Architect's Supplemental Instructions

PROJECT: *(name and address)*
Wilma P. Mankiller Health Center
Expansion
Stilwell, OK

ASI INFORMATION:
ASI Number: Bid Package 01 - ASI 002

Bid Package 01- ASI 02 – Wilma P. Mankiller Health Center Expansion

SHEET NUMBER:
S3.31
ROOF FRAMING SECTIONS

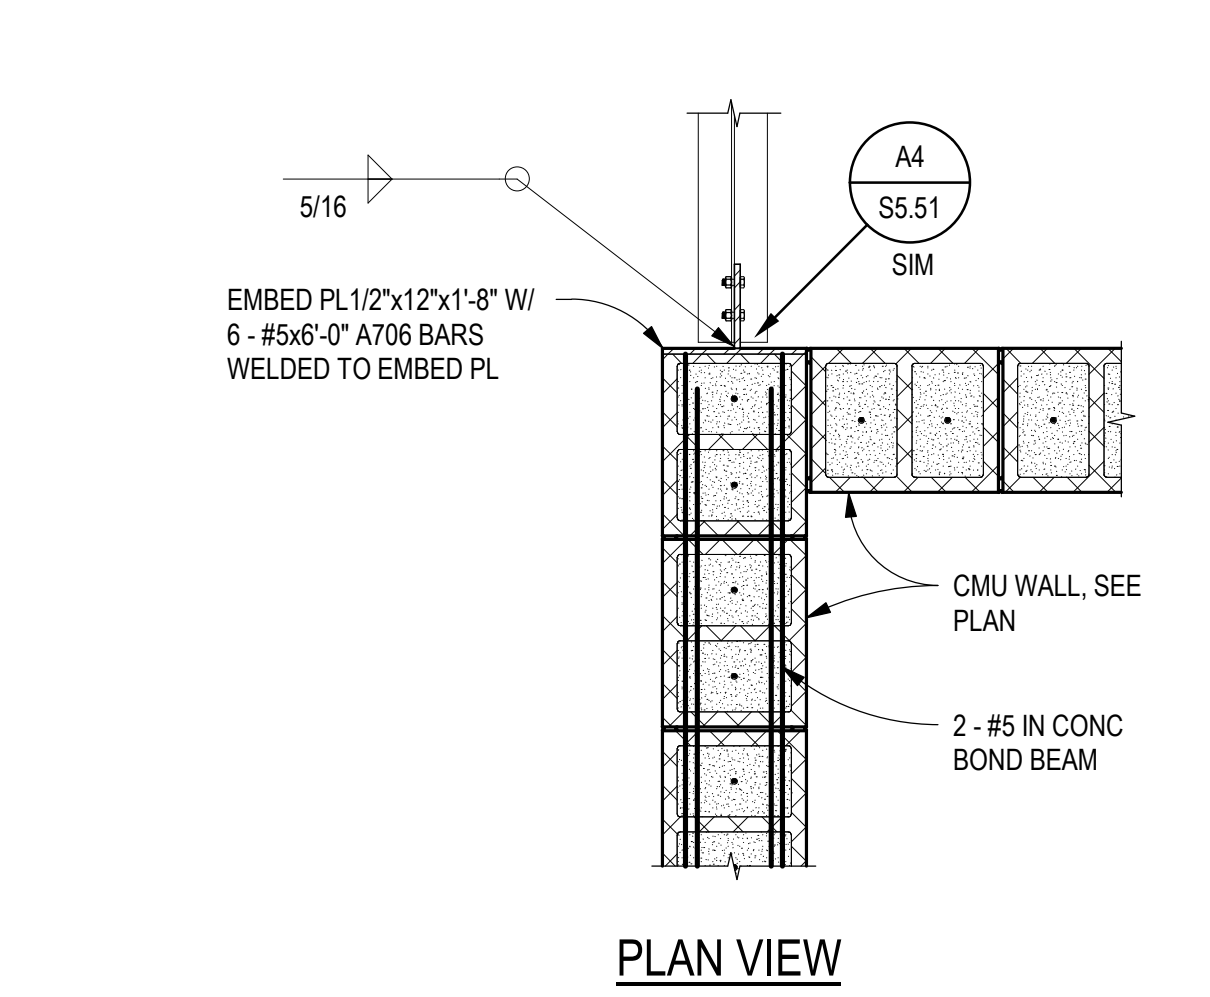
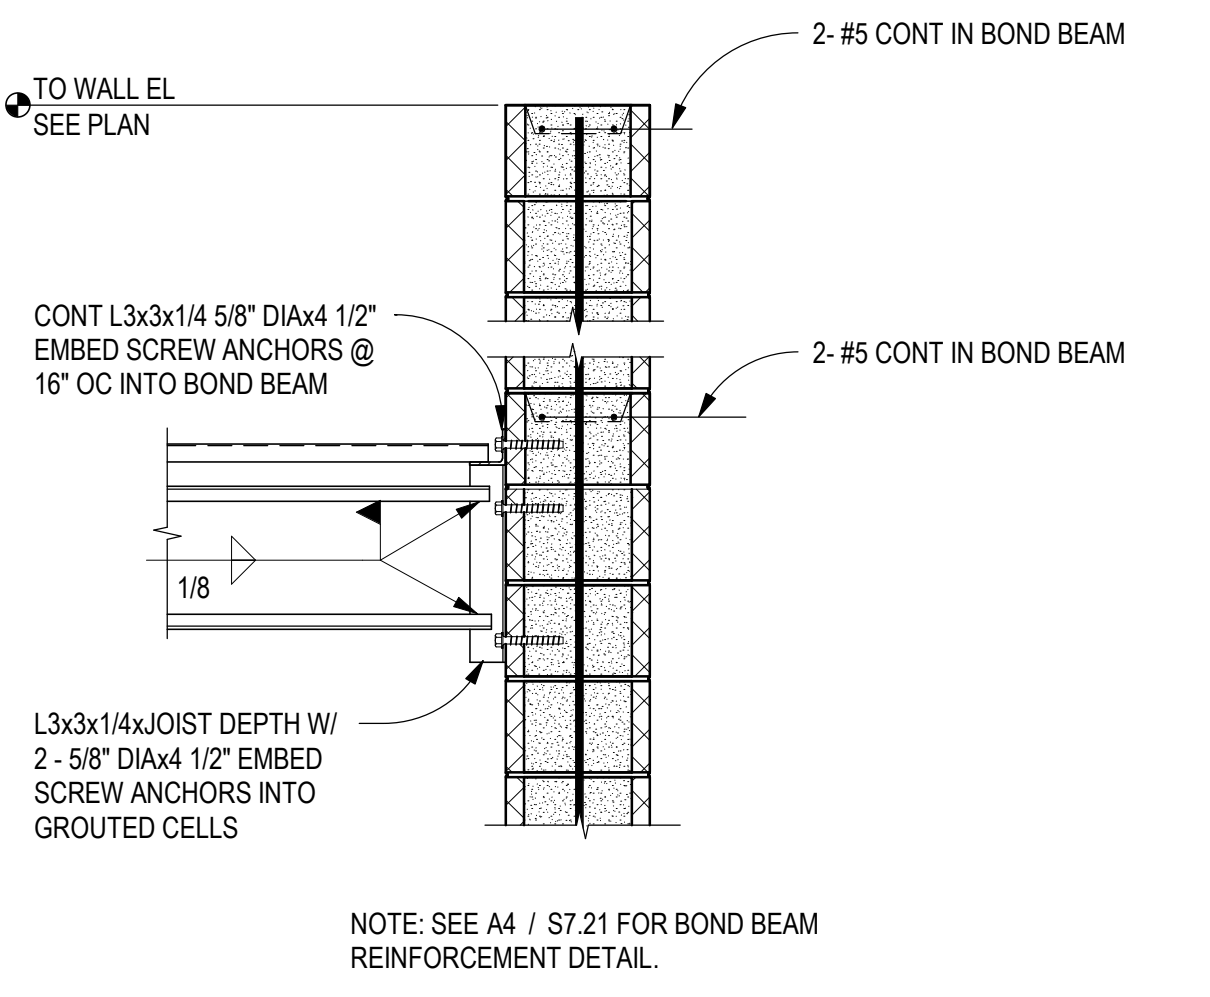
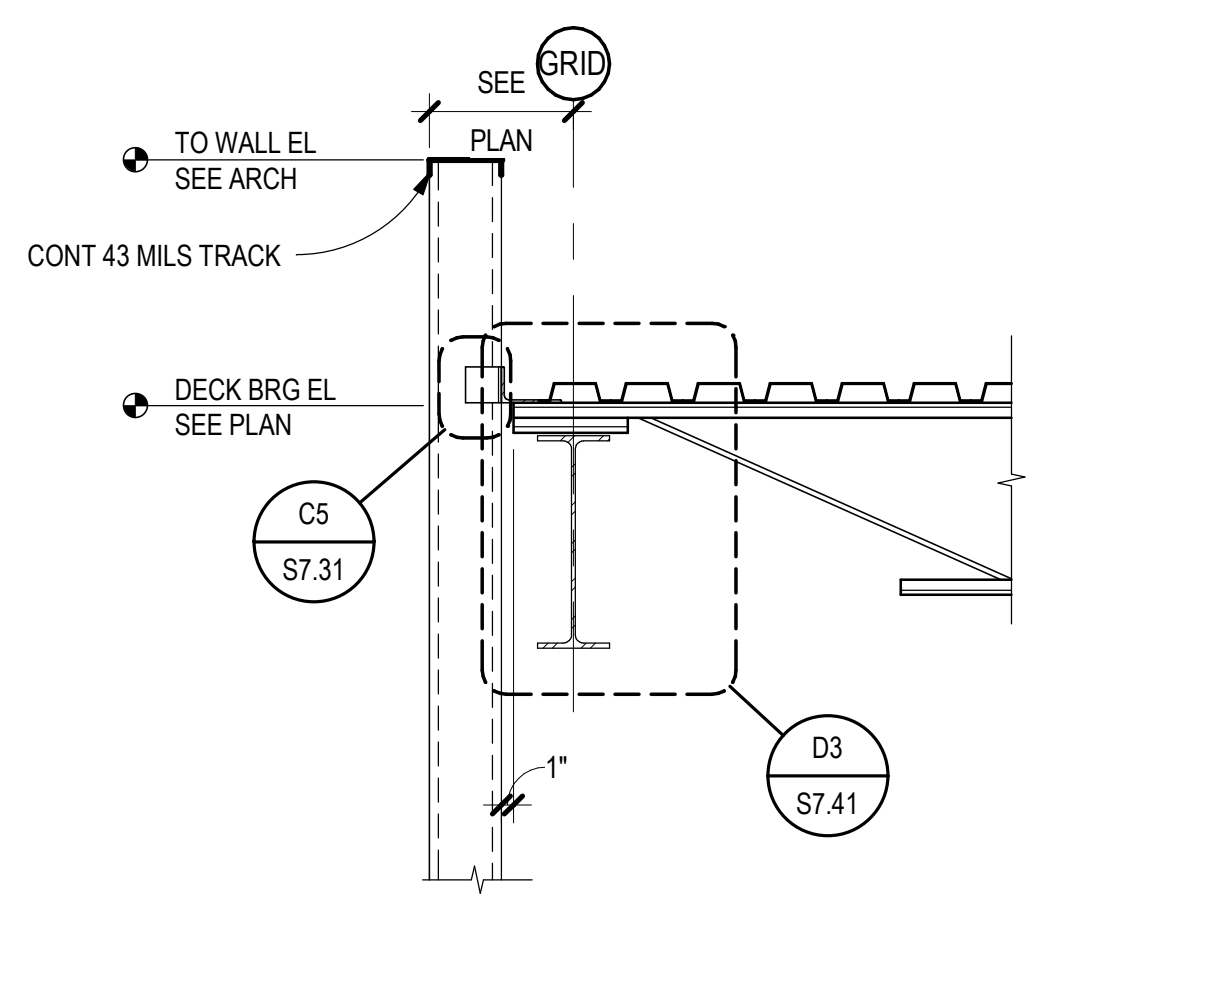
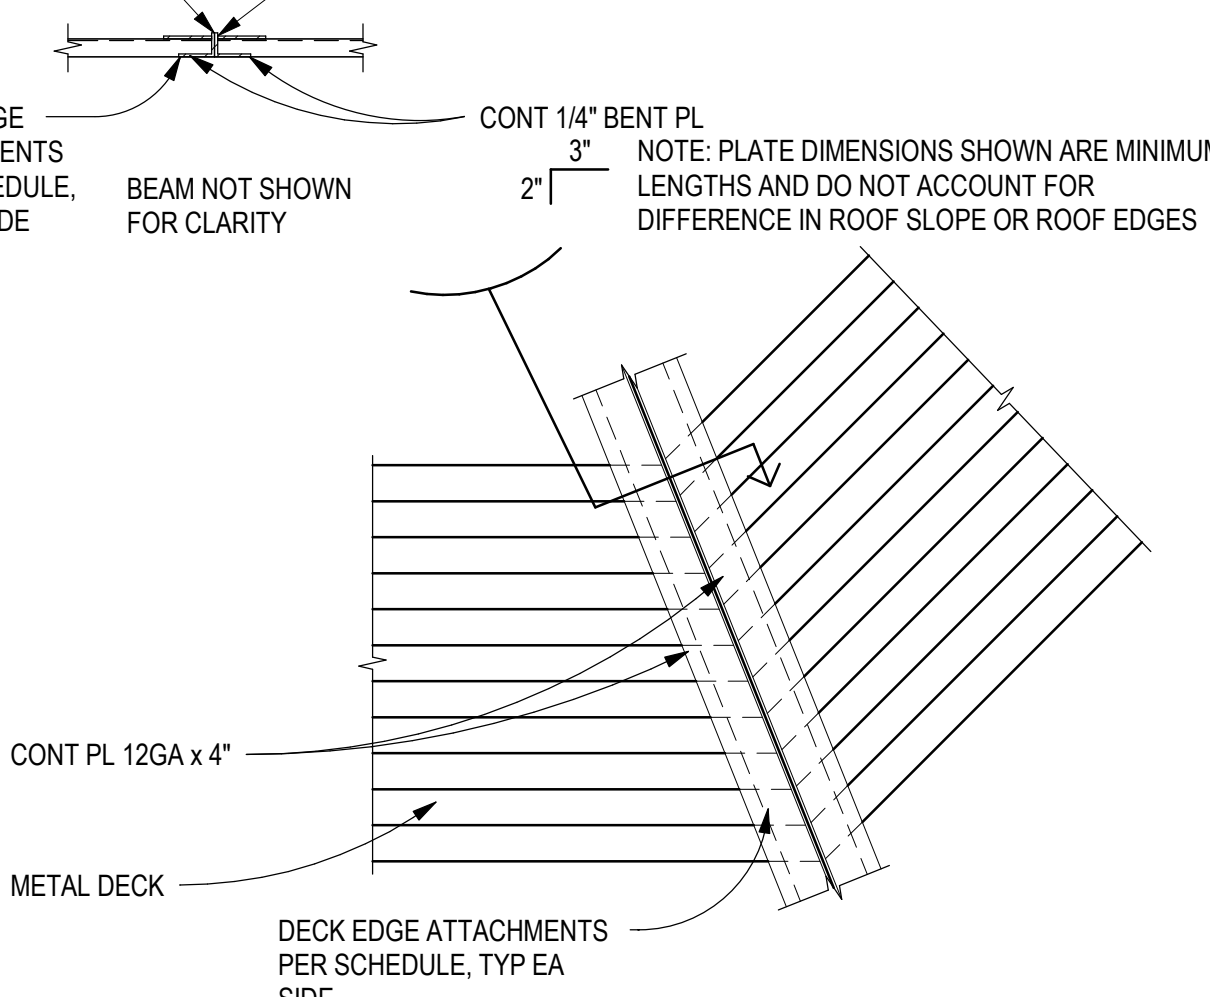
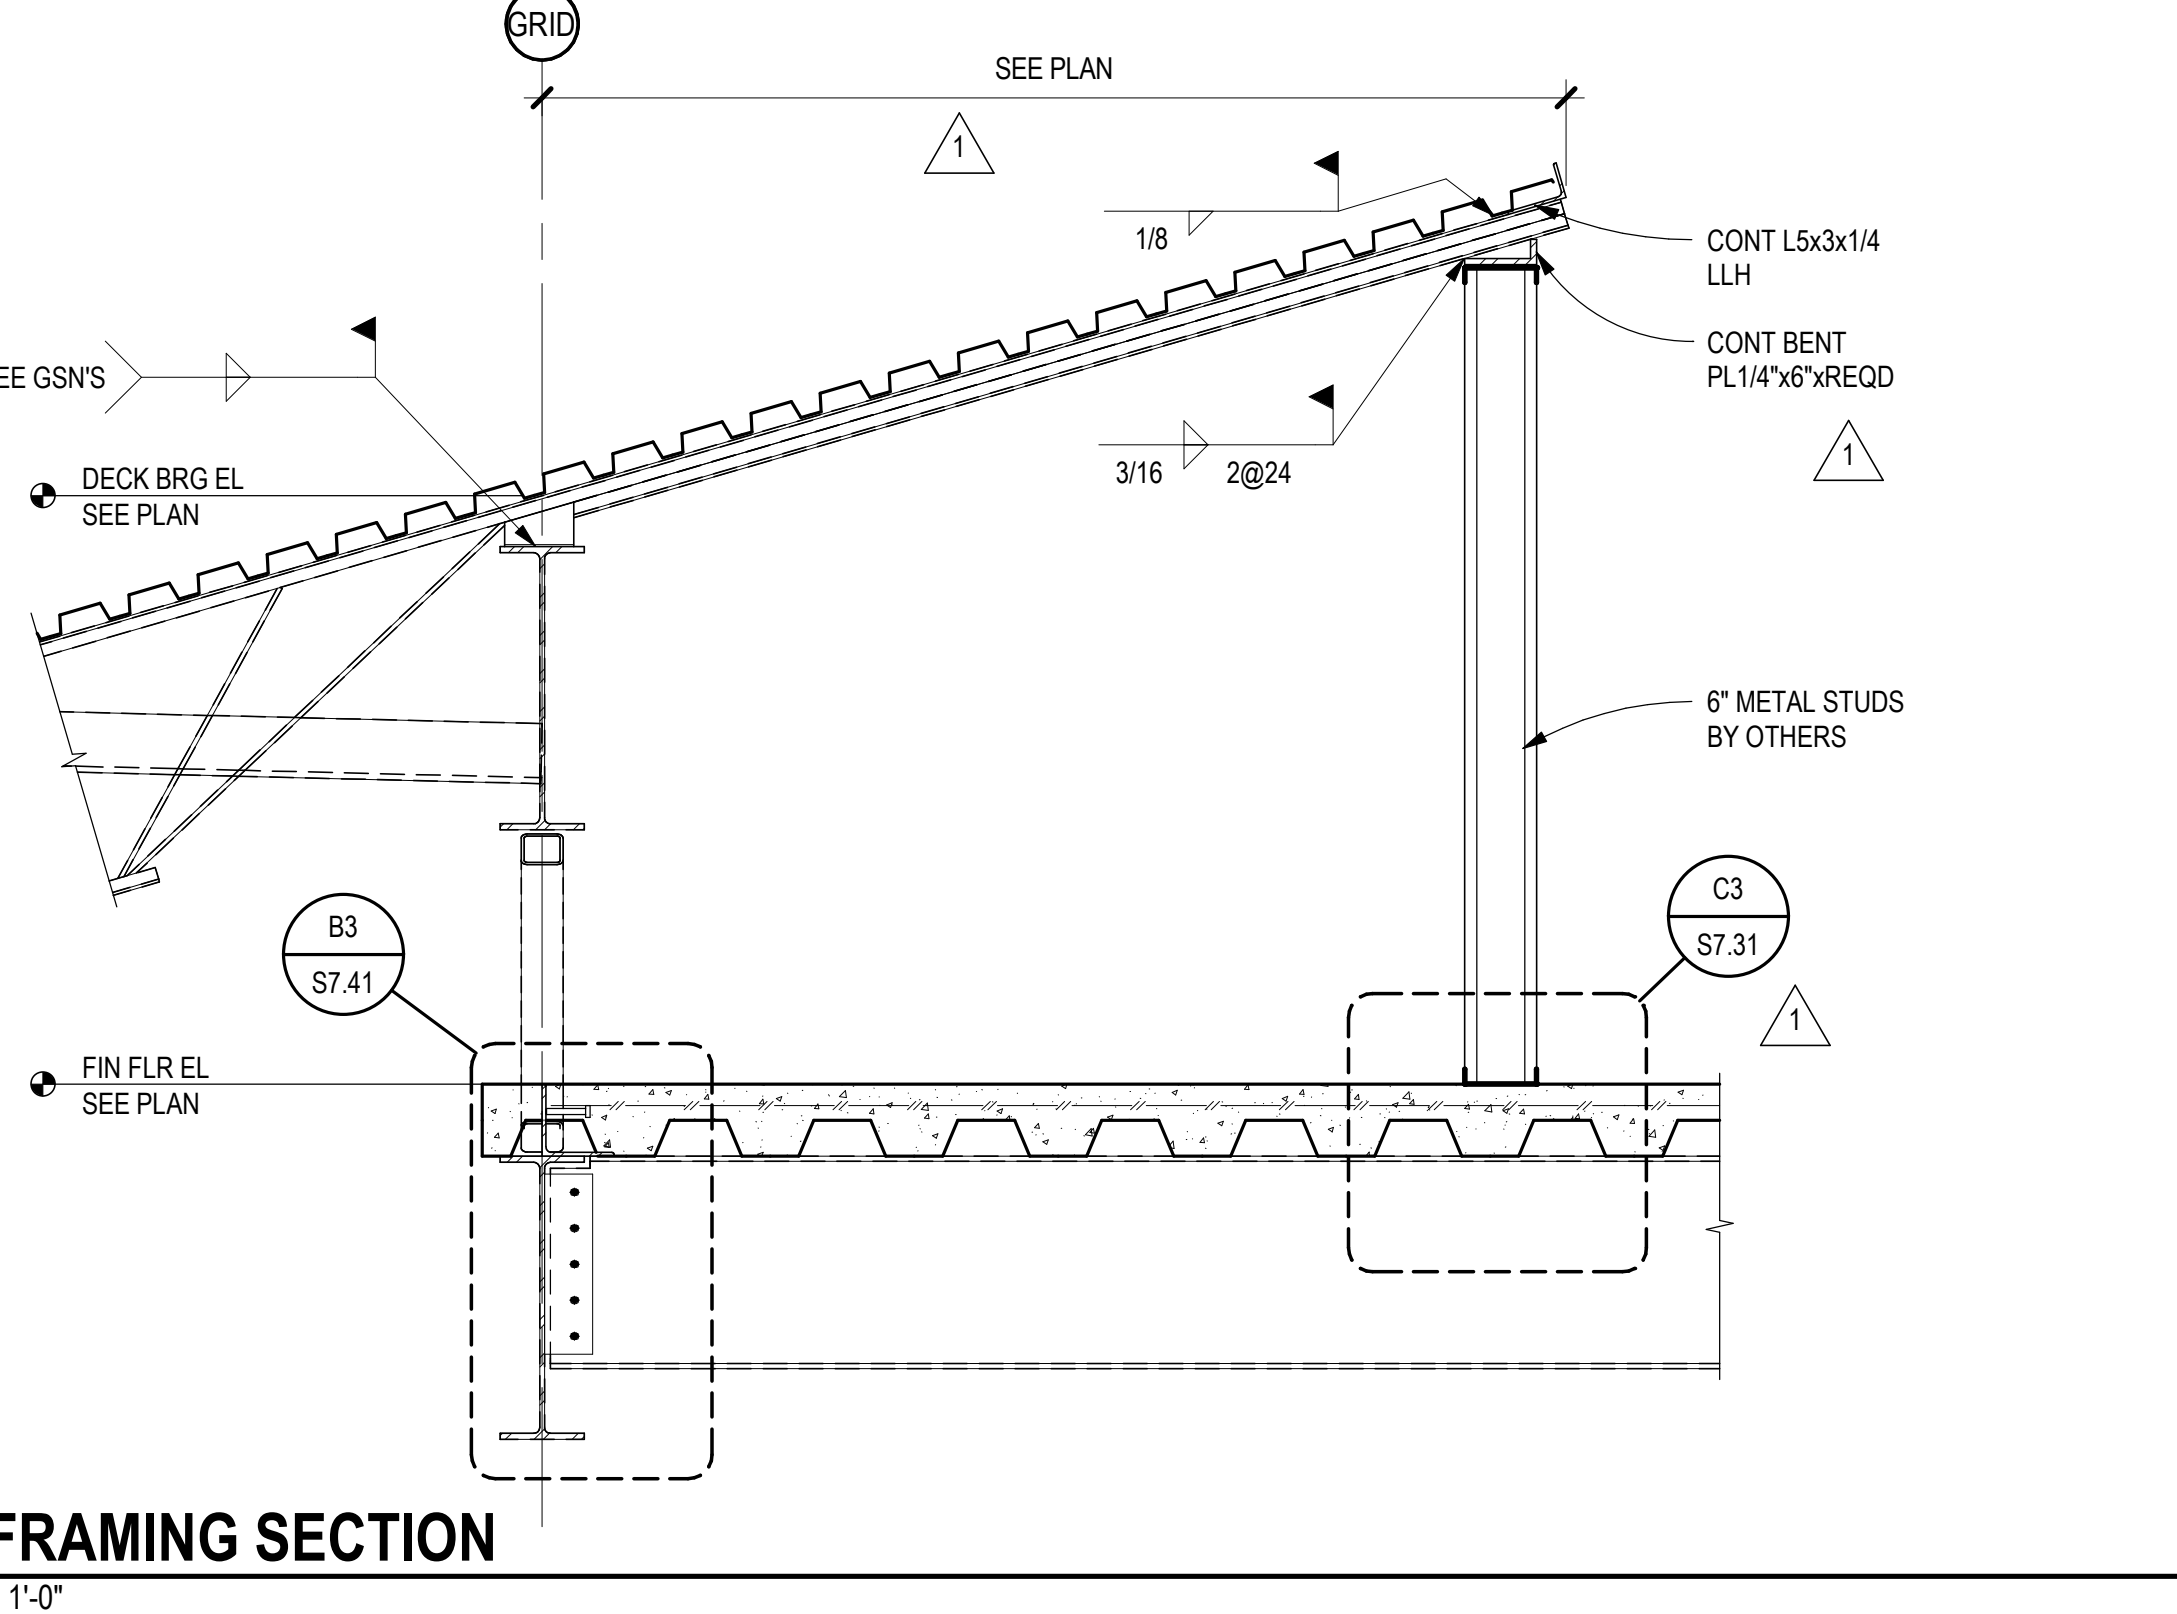
<u>Sheet</u>	<u>Description</u>
S1.13	Sheet keynote 12 removed from Grid 10.
S1.13	Section C1/S3.31 cut along Grid 10.
S1.13	Framing and deck edge near Grid G/10 modified.
S1.21	Beam sizes updated along Grid 10, between Grids G and D.
S1.21	Section C1/S3.31 cut along Grid 10.
S3.31	Section C1 added.
